Change Order Items.

MT EDGE CUMBE HIGH SCHOOL
BUILDING 1330
ACADEMIC EXPANSION

Project Number 67751C
Sitka, Alaska
DECEMBER 13, 2004

SHEET A003

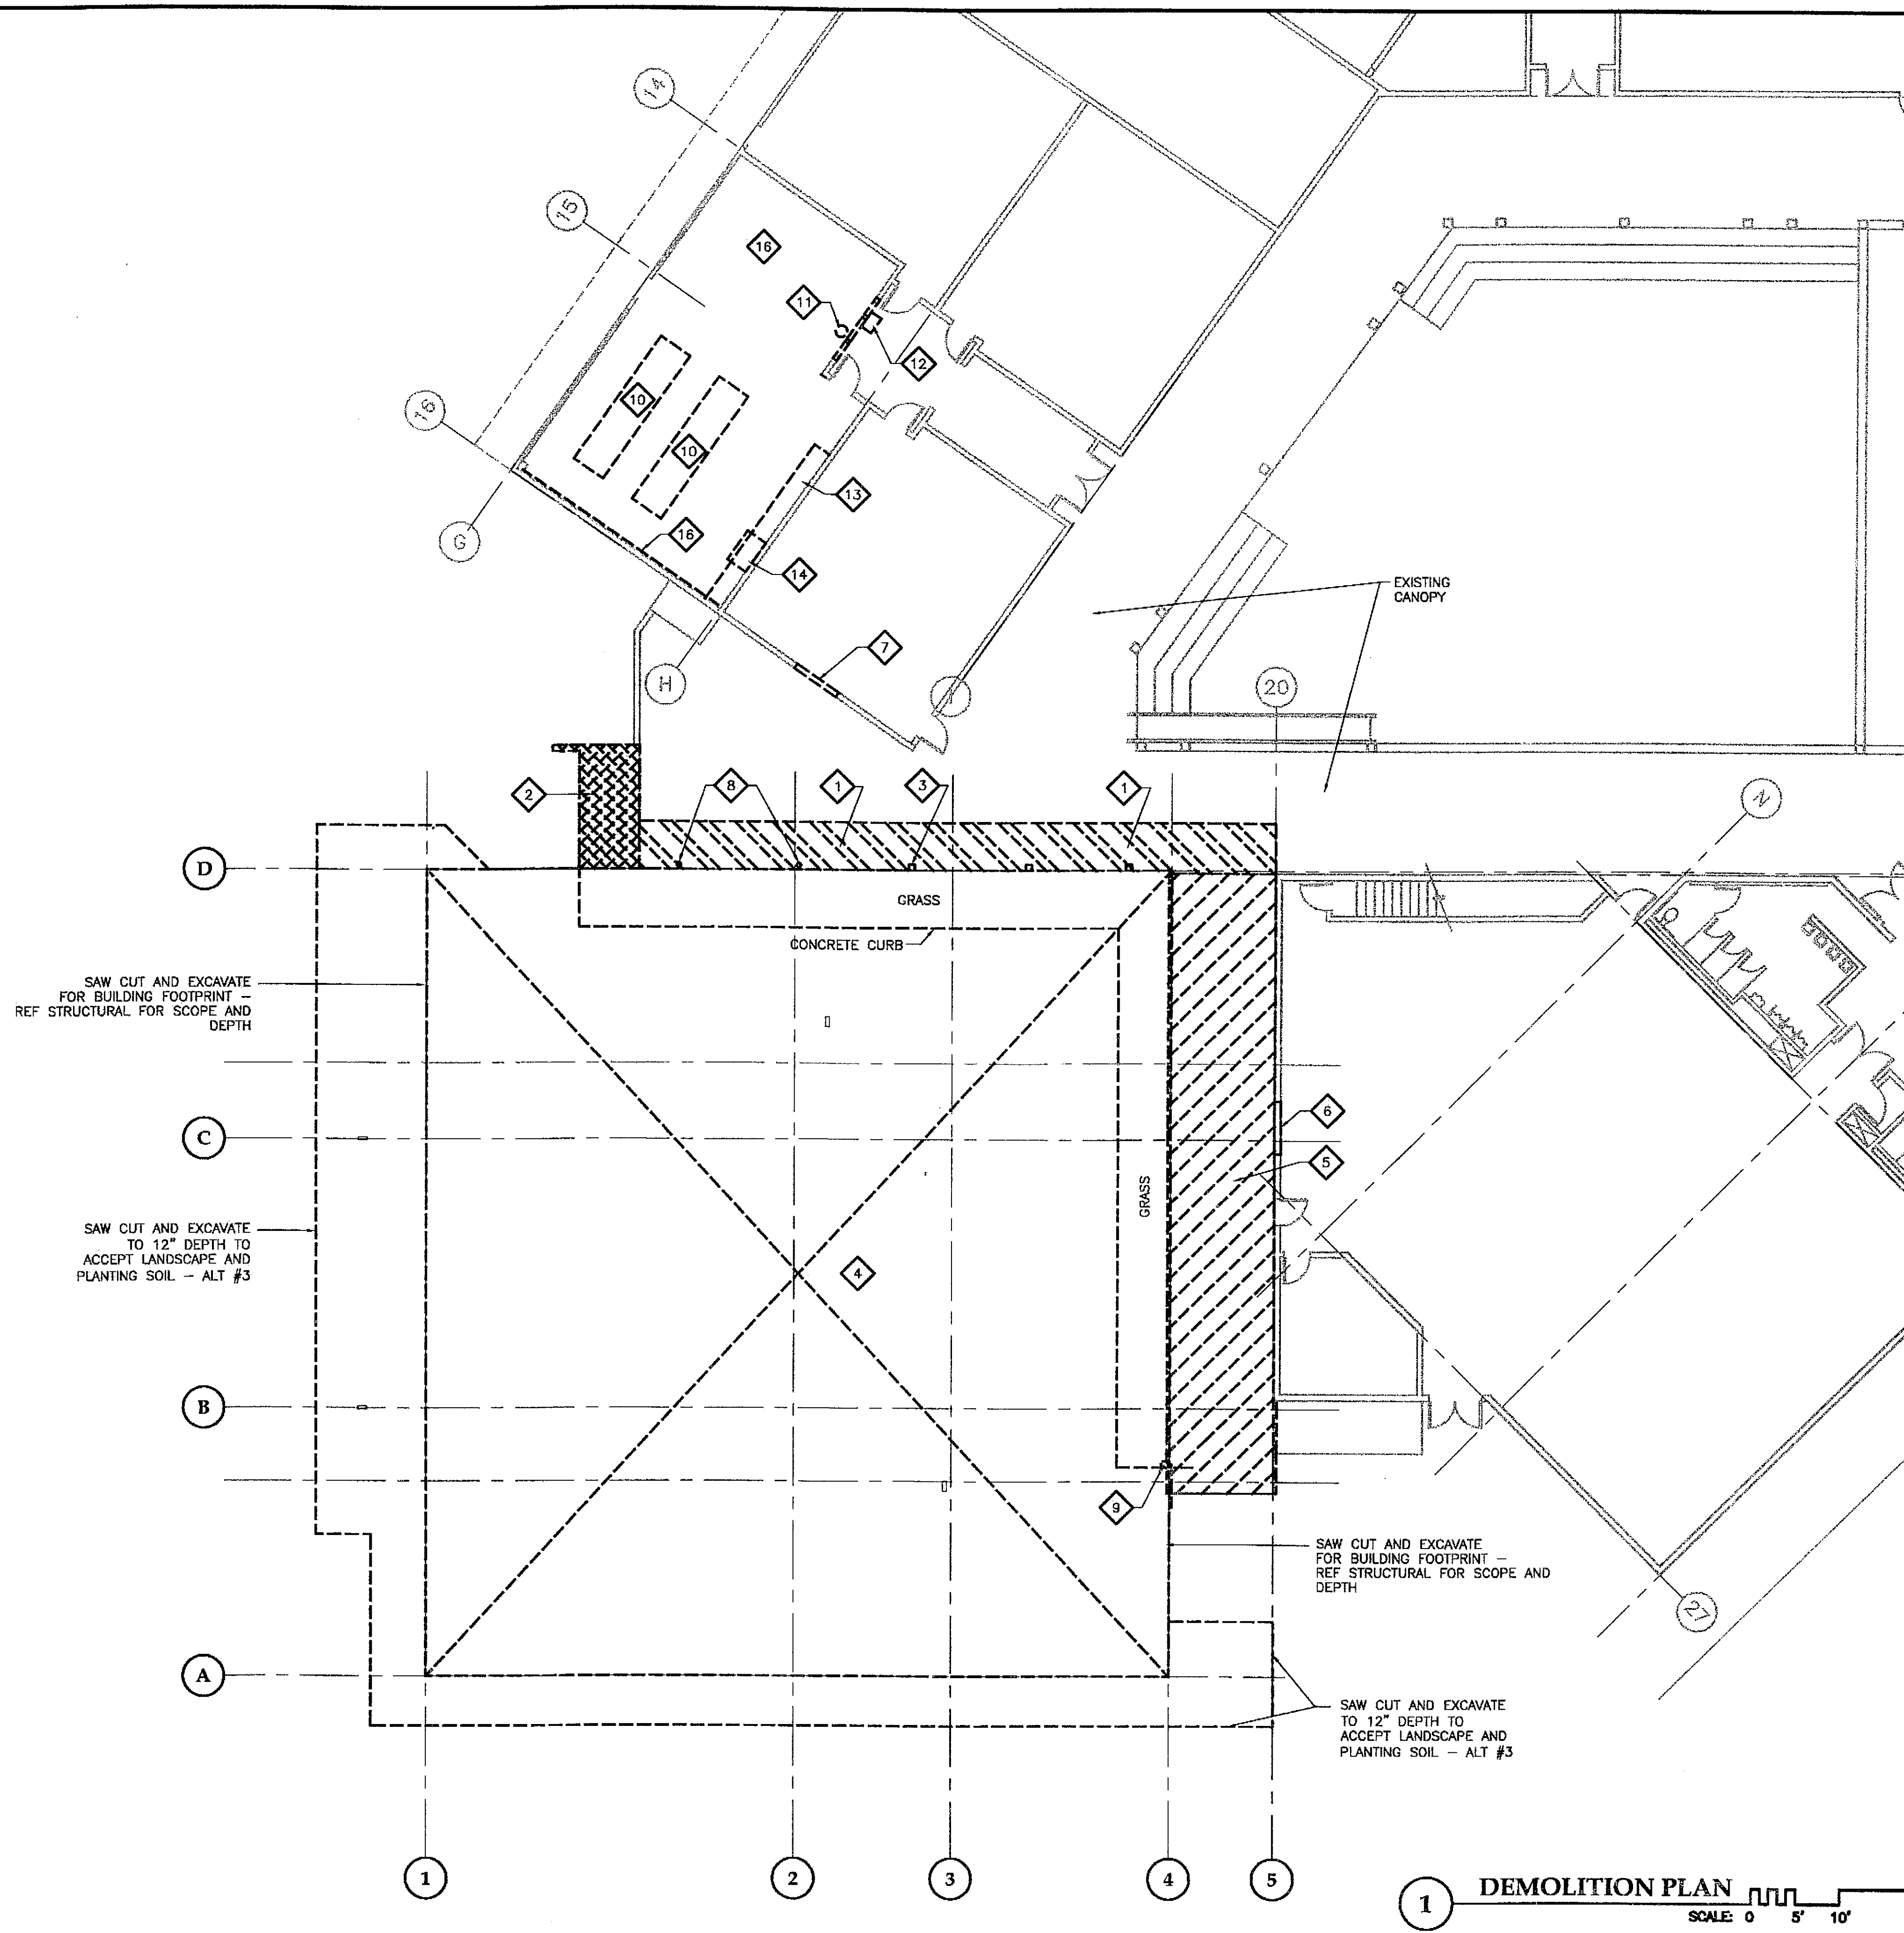
Co#1 Add A-1 windows to RMS 14/142
143, 145. See sheet
Co#2 Add equipment to page

SHEET M101

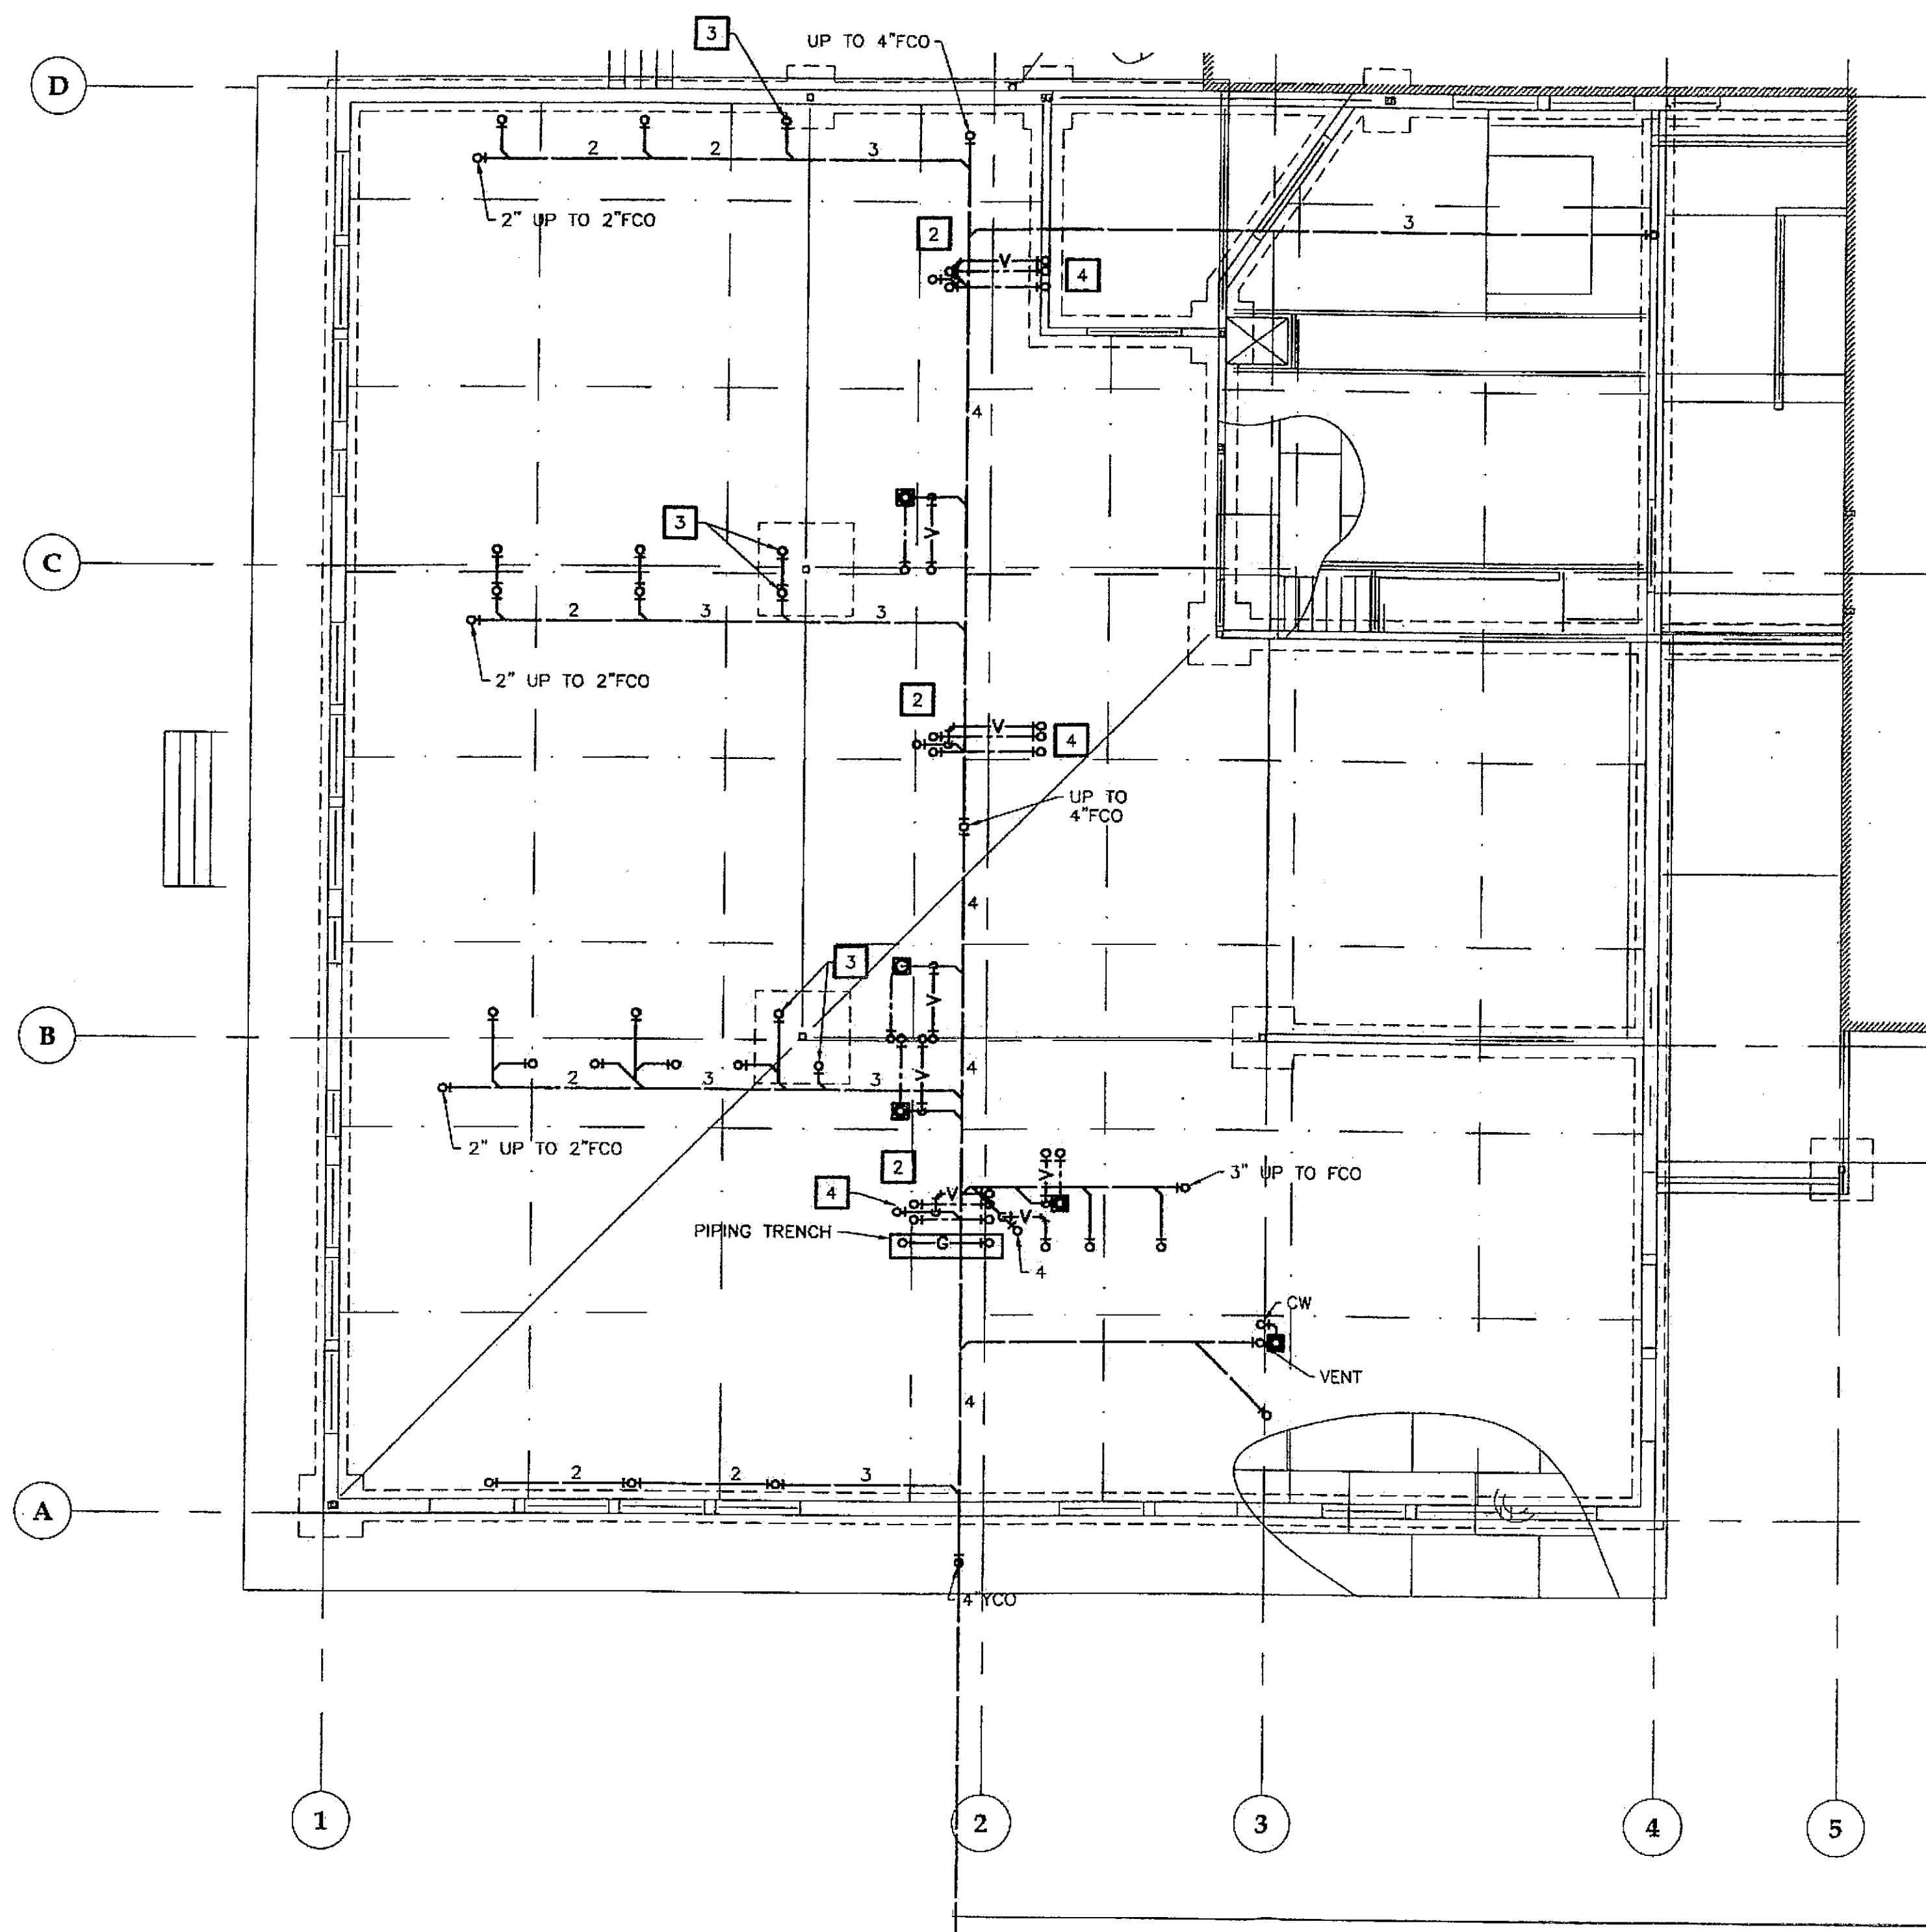
Fuel Lines
Cott 10
Remove Fuel Lines.

SHEET M201

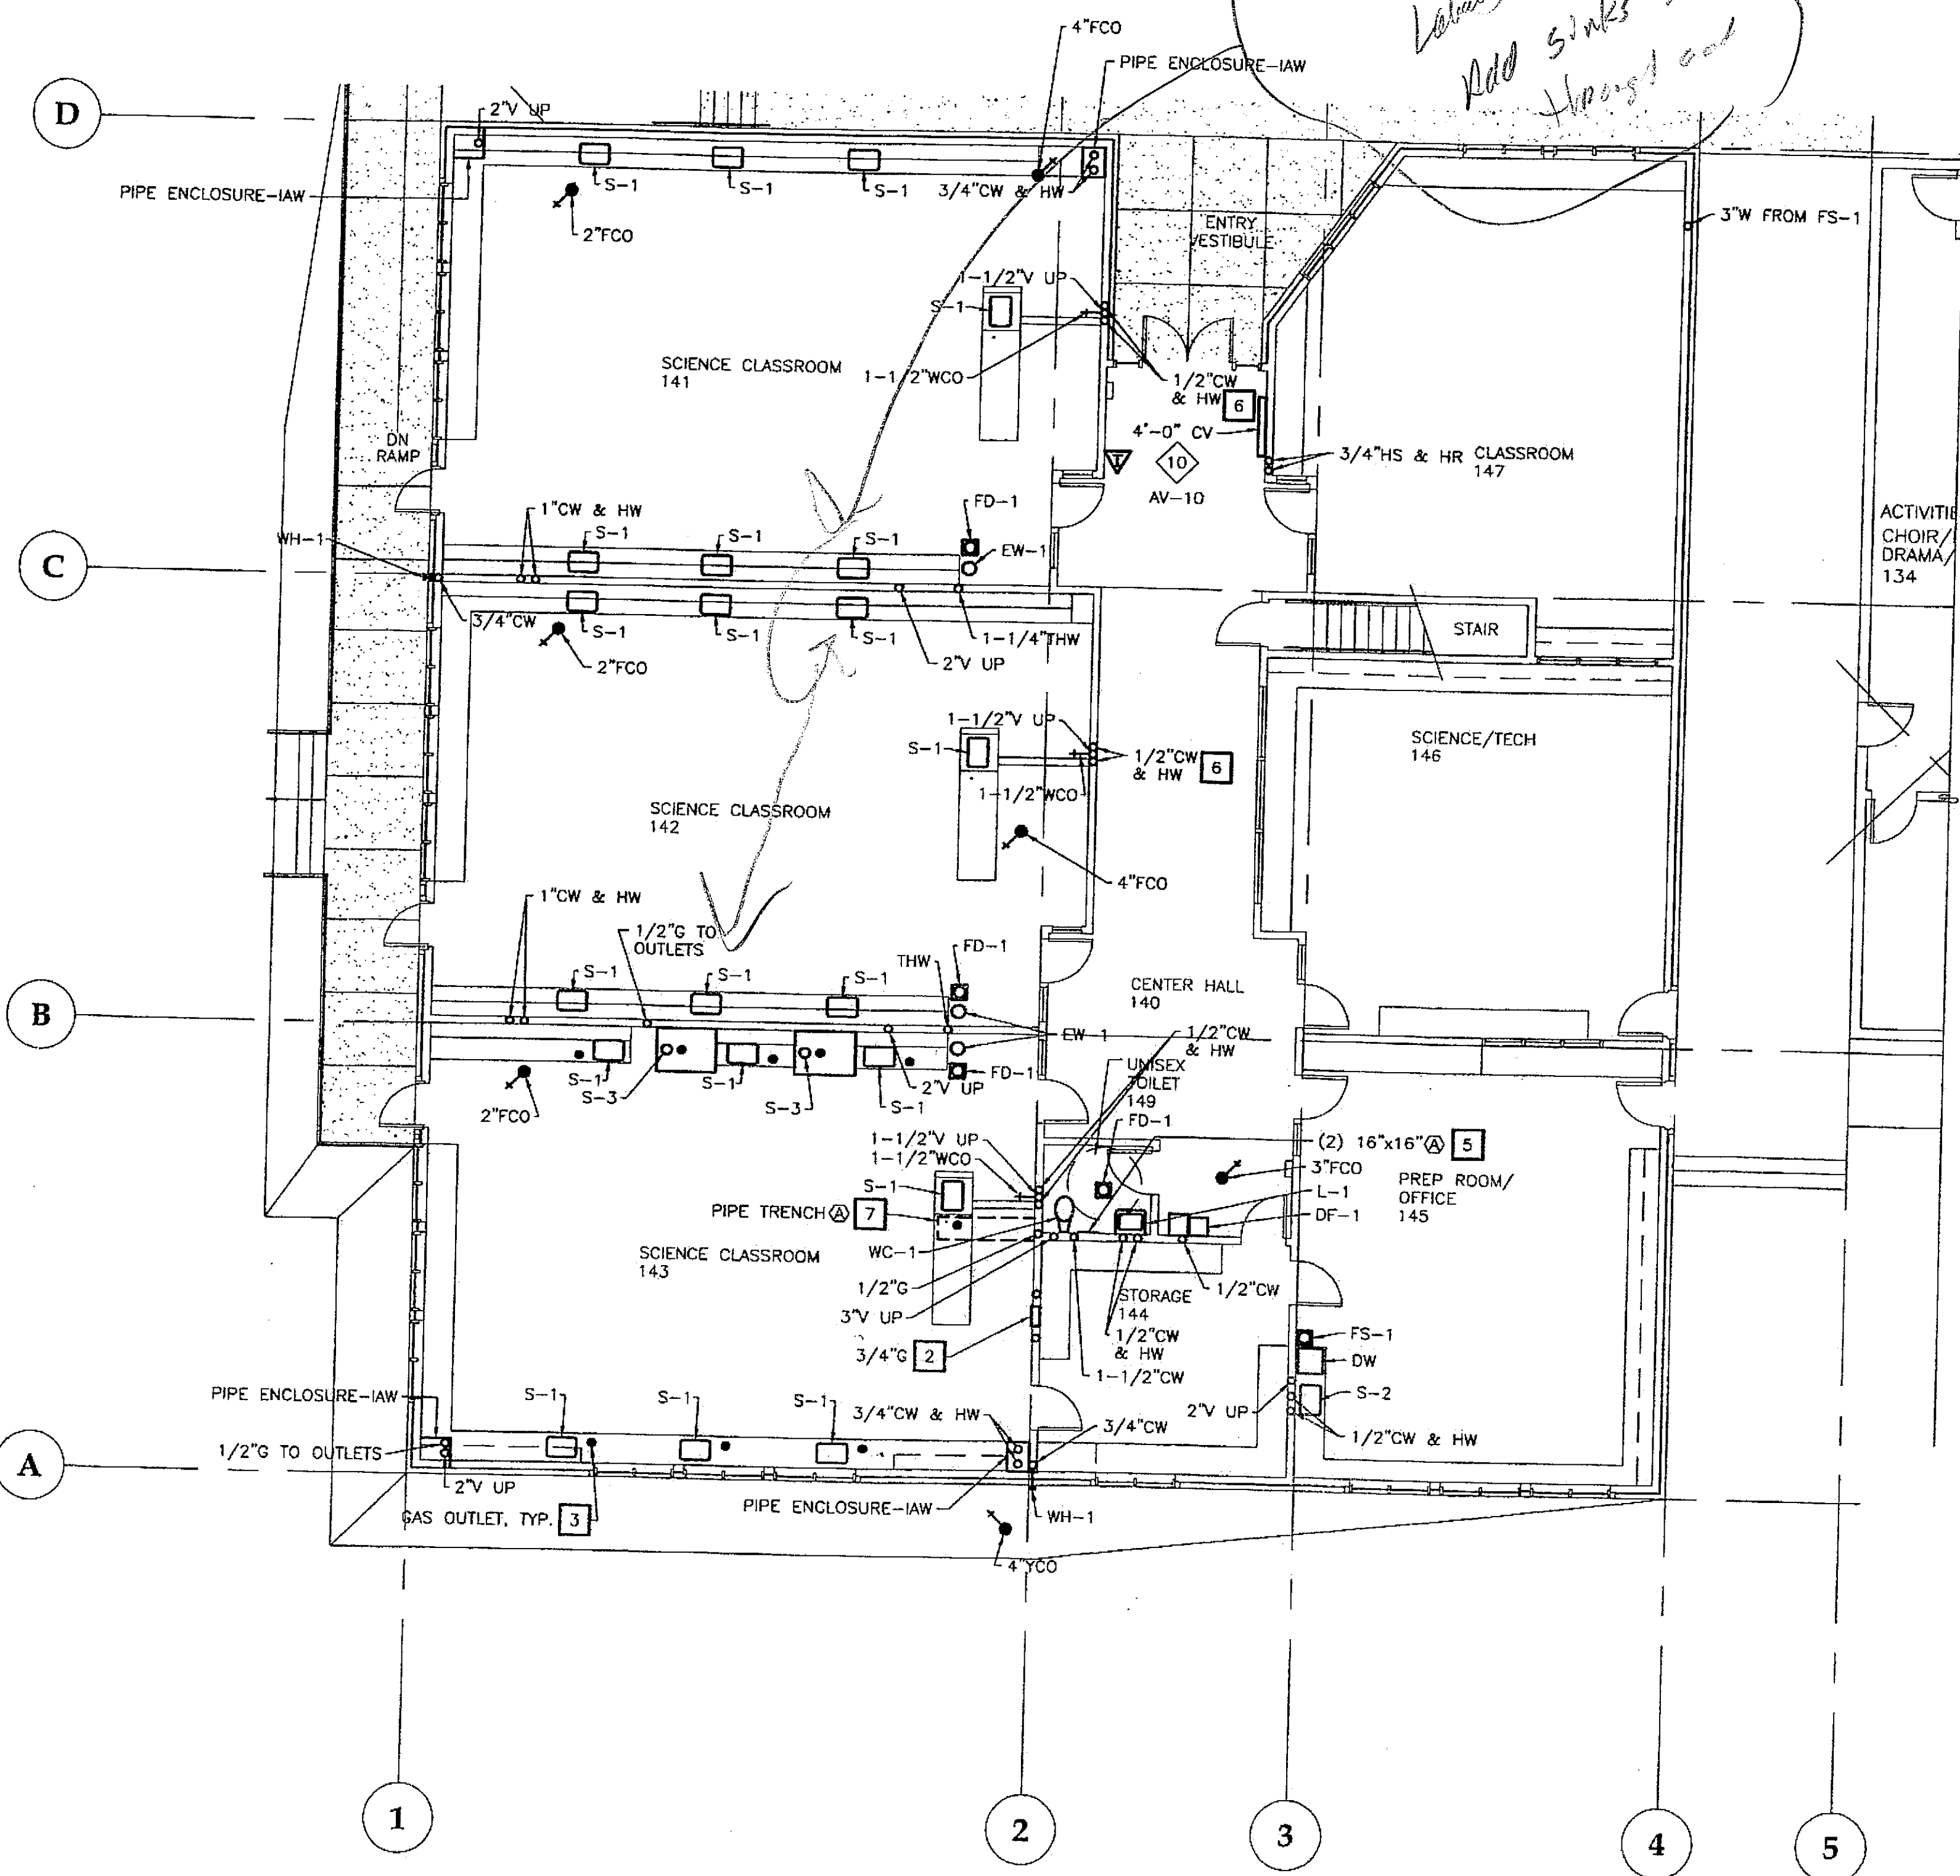
Lot 2
 Lab by Eq.
 Add sinks S-1
 Housed and
